10 November 2025

Pukekohekohe Gateway Plan Change Request – Response to Clause 23(2) Supplementary Further Information

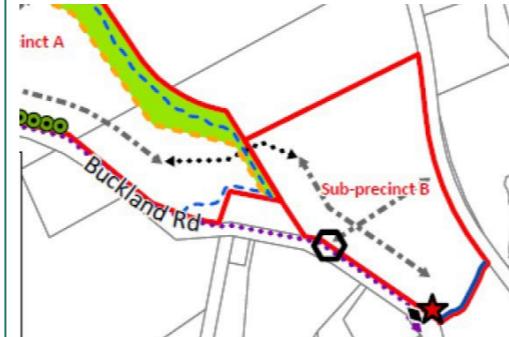
Reference	Category of Information	Specific Request	Status / Supplementary Further Information Requested 11 September 2025	Applicant Response 3 October 2025
T 10		<p>Please provide an assessment of the chosen location of the southern key intersection into Sub-precinct B that demonstrates that the location is safe, has appropriate visibility and that the road is suitable for the proposed intersection (including any widening for the right turn bay).</p> <p>This should take into account the existing and anticipated future speed limit on Buckland Road.</p>	<p>The assessment of visibility at the access is acknowledged.</p> <p>However, a concept design is required of the intersection to demonstrate its feasibility, taking into account the constraints to the north of the access to provide widening for the right turn bay. This may also impact on the ability to provide the shared path as indicated on the drawings in Appendix 9 of the response.</p> <p>Please provide a concept drawing of the southern intersection to demonstrate that an intersection is feasible at the location proposed.</p>	<p>A concept drawing of the southern intersection is included at Attachment 3. A snip is also provided below for ease of reference:</p>

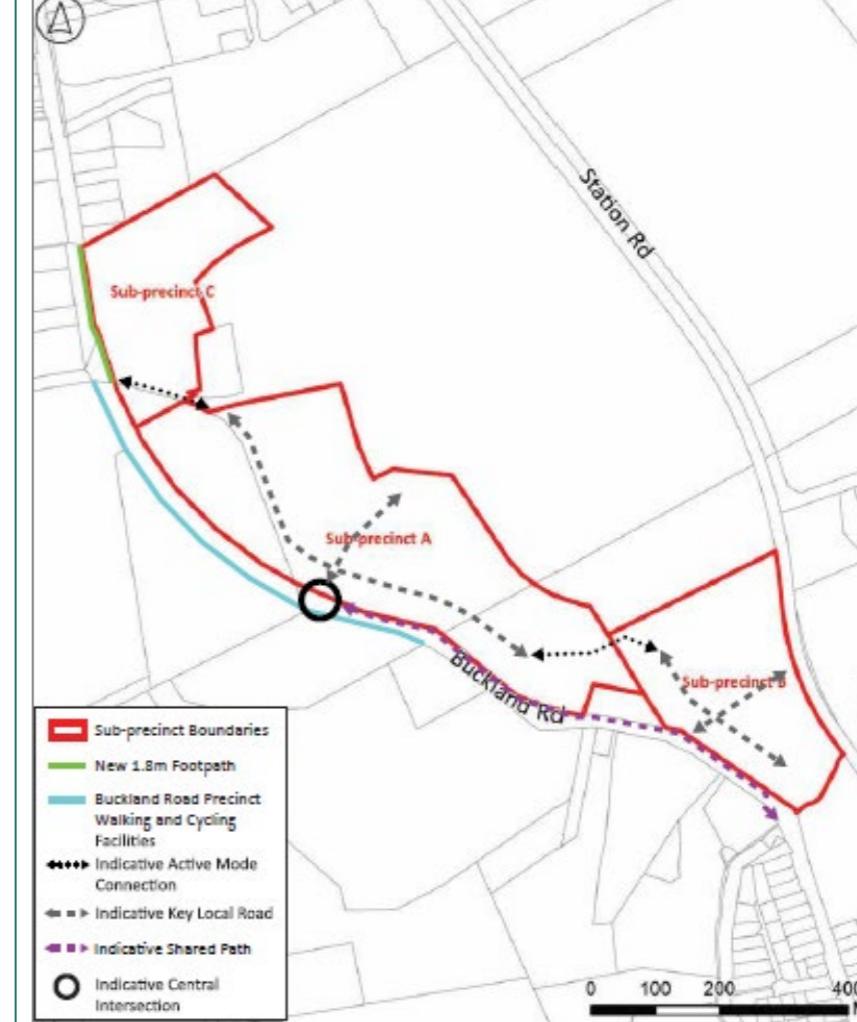
PL 5	Land covenant (Instrument No 10148071.4)	<p>Land covenant (Instrument No 10148071.4) included in the bundle of certificates of titles grants rights relating to Wastewater Operations (Pukekohe Wastewater Pump Station (WWPS)). Clause 6 references operations that generate noise, odour and visual effects. While this is a covenant between the parties, please advise:</p> <ol style="list-style-type: none"> What consideration has been given to the implications of this covenant on the proposed re-zoning of adjoining land for residential activities. What standards may be necessary in the precinct plan to address this matter. For example, the Neighbourhood Design Statement outlines that the Precinct Provisions include urban design-related provisions aimed at ensuring successful development outcomes, including the establishment of a 'physical buffer' with WWPS. 	<p>This matter is still being considered.</p>	<p>Noted.</p>
